# VNI West – Final Compliance Report

June 2023

Regulatory Investment Test for  
Transmission

Figure 1 – New South Wales study area for all options in the Additional Consultation Report

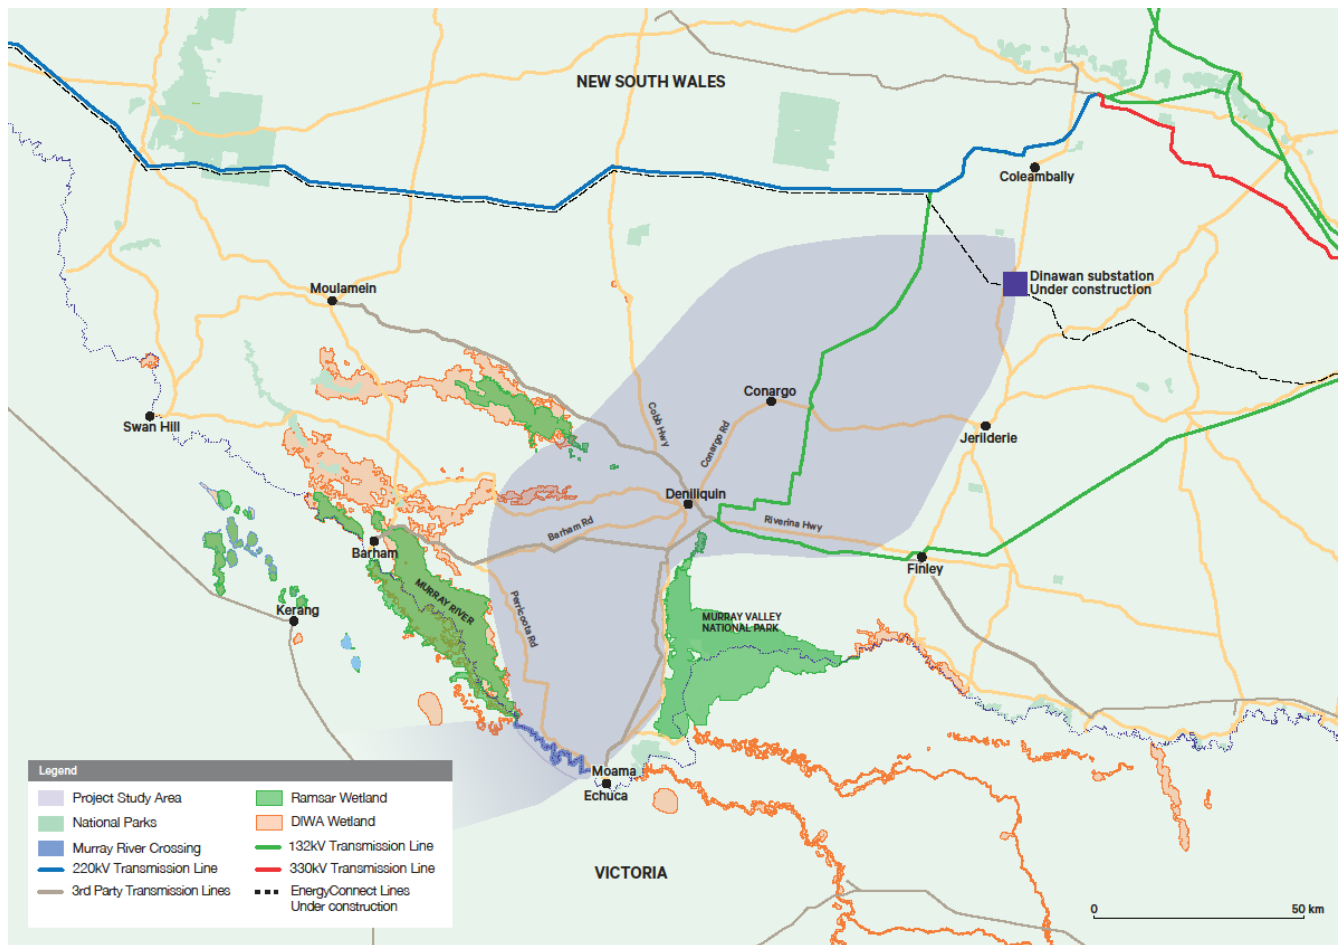
The fourth issue the AER is seeking further information on is why only limited analysis of the New South Wales component was provided. Specifically, the AER has requested further information on:

- option selection for routes between Dinawan and the Murray River crossing points;
- the cost benefit analysis of these options; and
- the infrastructure to be built to the preferred crossing point.

For all seven options assessed in the Additional Consultation Report (Options 1, 1A, 2, 3, 3A, 4 and 5) AVP and Transgrid note that the technical characteristics and costs in New South Wales are the same with the exception of Option 2 that included an additional non-network solution in the form of a Virtual Transmission Line (VTL).

In general terms, the technical characteristics in New South Wales involve an upgrading (or enhancement) of the connection between the Dinawan substation, being delivered as part of EnergyConnect, from double-circuit 330 kV to double circuit 500 kV, and the construction of 184 km of new double-circuit transmission line from Dinawan to the Murray River near Echuca.

The indicative route from Dinawan to the Murray River was derived from the approximate centre of a New South Wales study area that avoids significant development constraints, including wetlands protected under the Ramsar convention<sup>12</sup>, and aligned with the area of interest for the Victorian component of VNI West.

The New South Wales study area for all options presented in the Additional Consultation Report is shown in Figure 1 below.
